Service Bulletin  
TM 315-37

GROB  
G 103 TWIN II  
G 103 A TWIN  
II ACRO

Subject: Inspection and reinforcement of welded parts in the flight control system of the gliders GROB G 103 TWIN II and G 103 A TWIN II ACRO. The following welded parts will be reinforced:

Explanatory Sheet for the Execution of Instruction 1 of TM 315-37  
for s/n 3501 - 3729

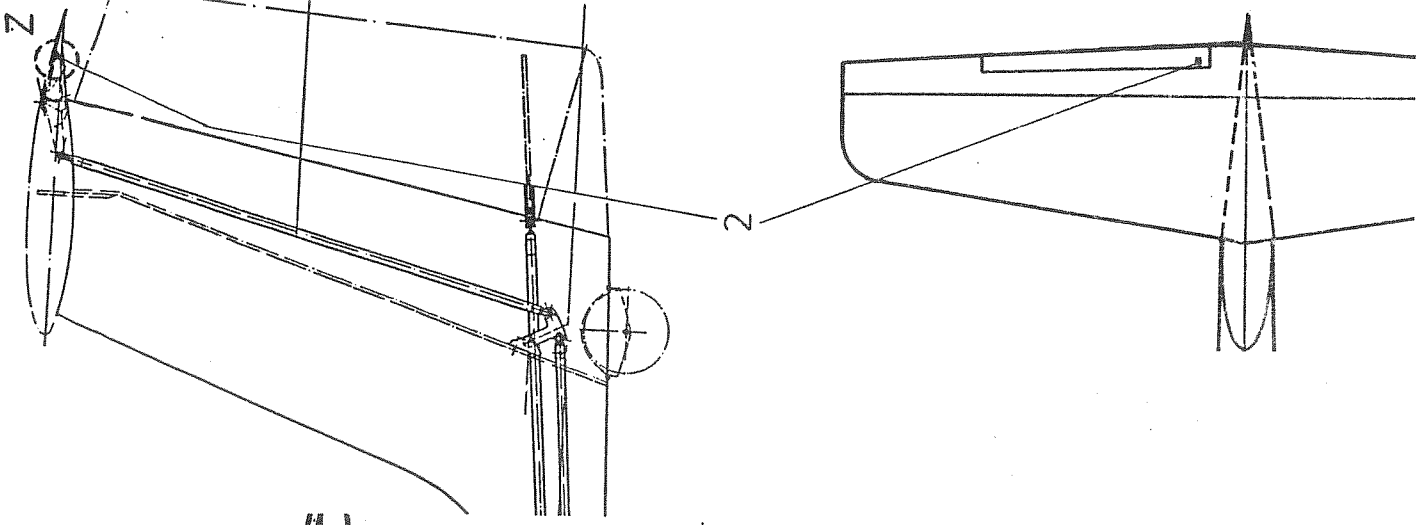
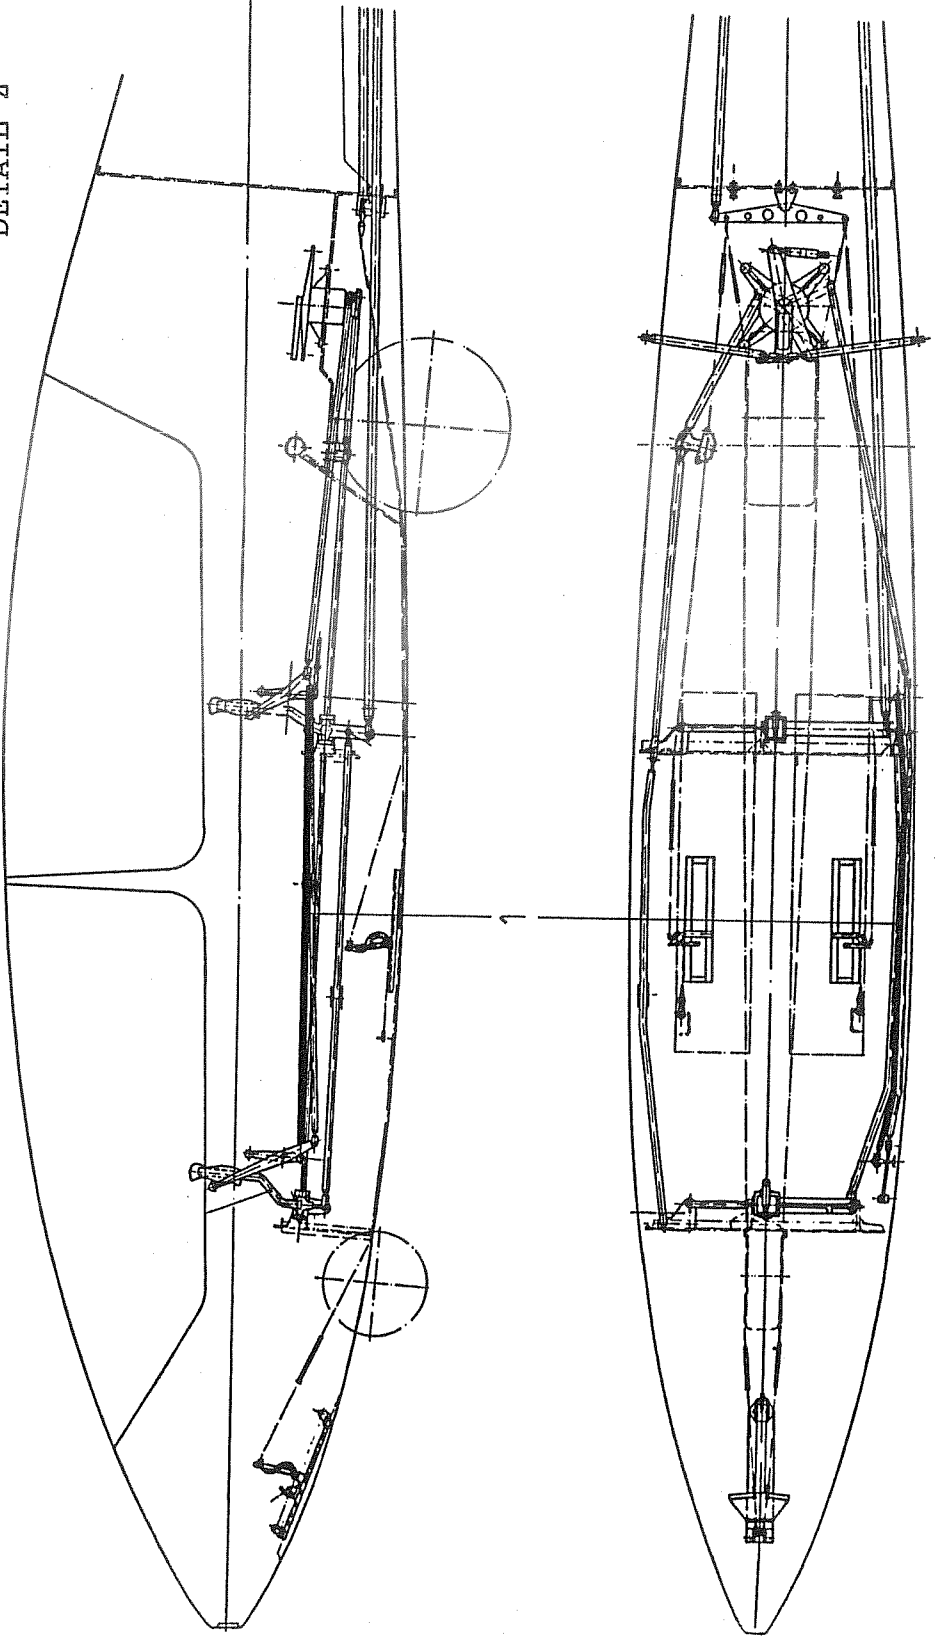
The control system parts shown below have to be inspected for cracks and deformations.

Explanatory Sheet for the Execution of Instruction 1 of TM 315-37

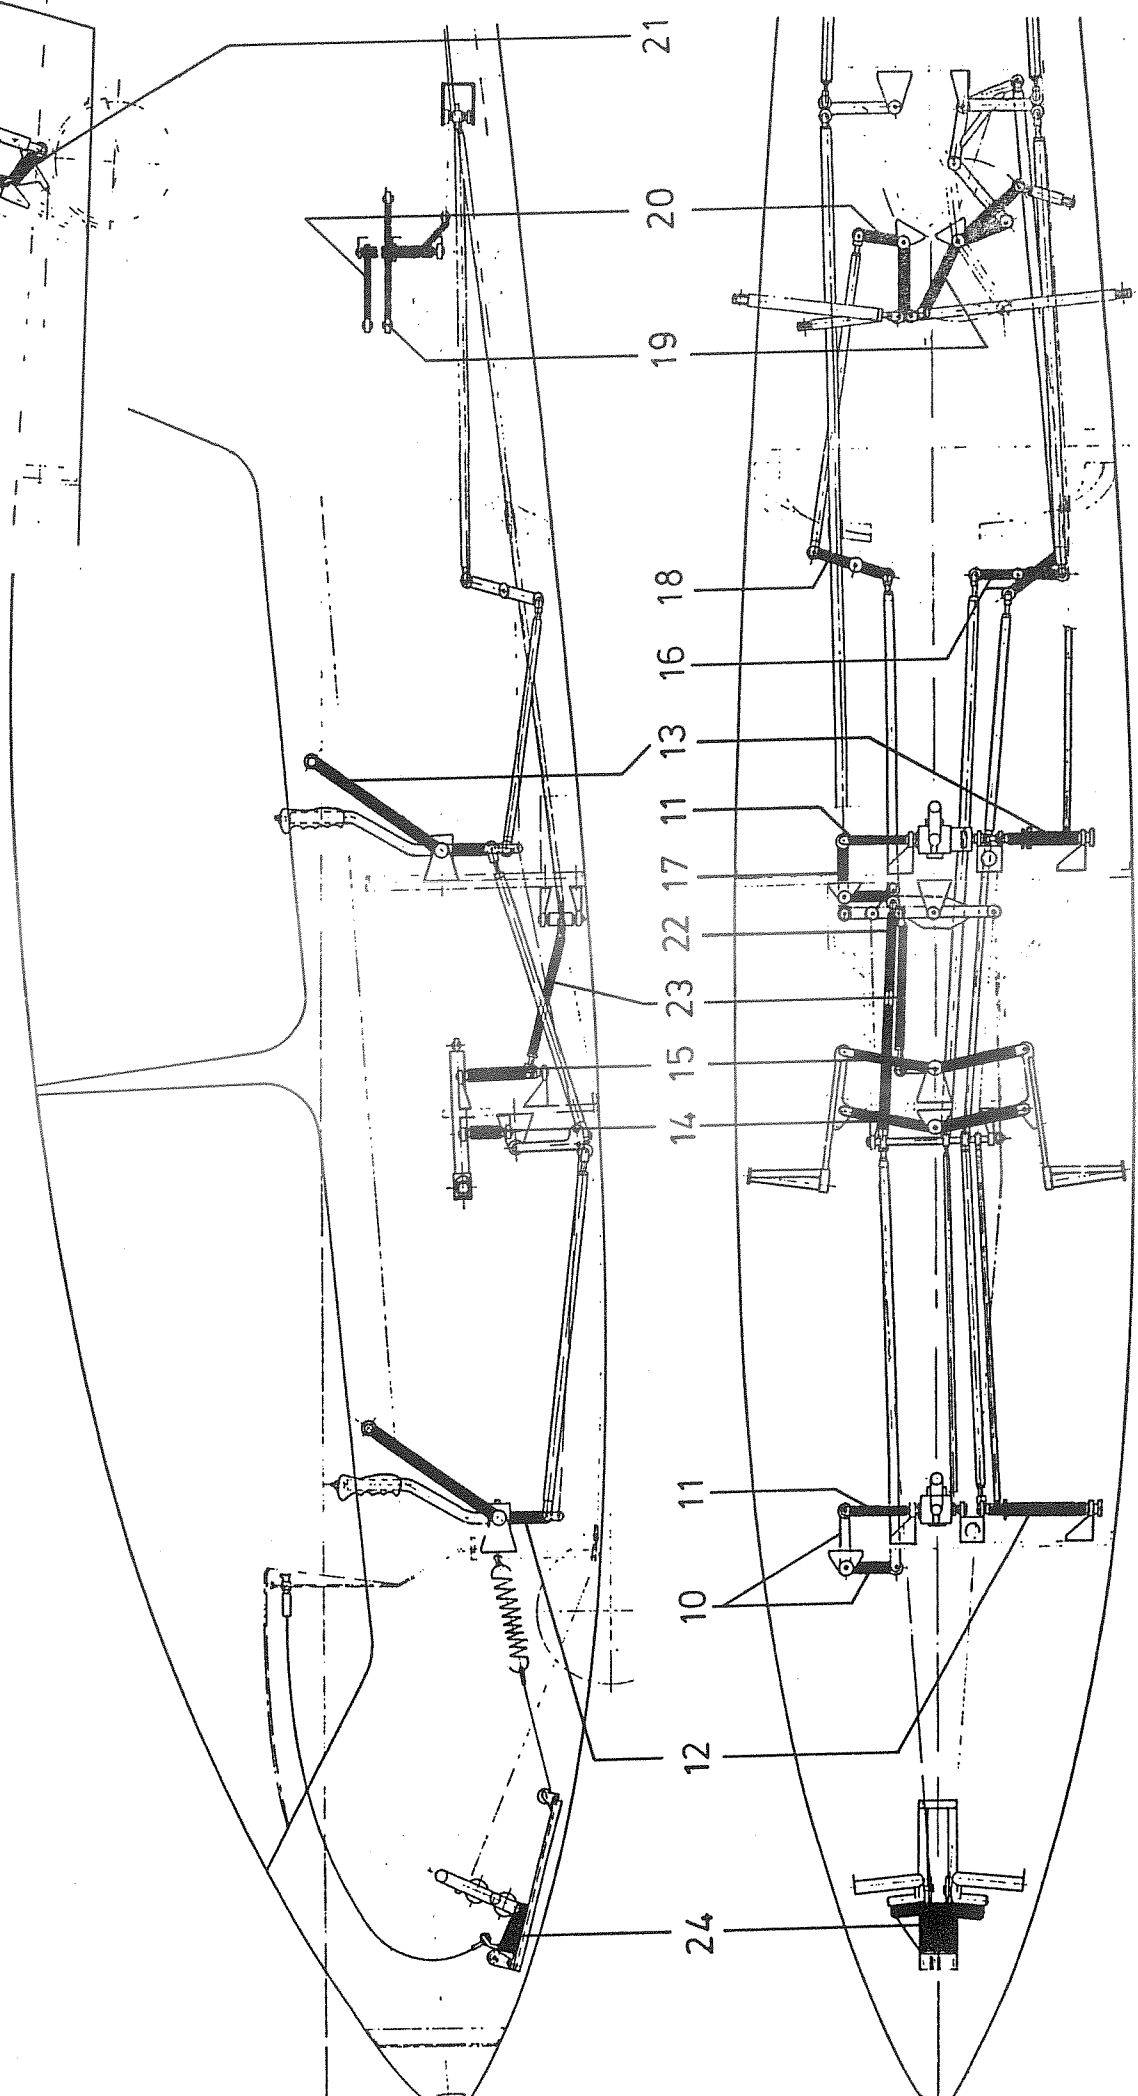
The control system parts shown below have to be inspected for cracks and deformations in the area of the welds.
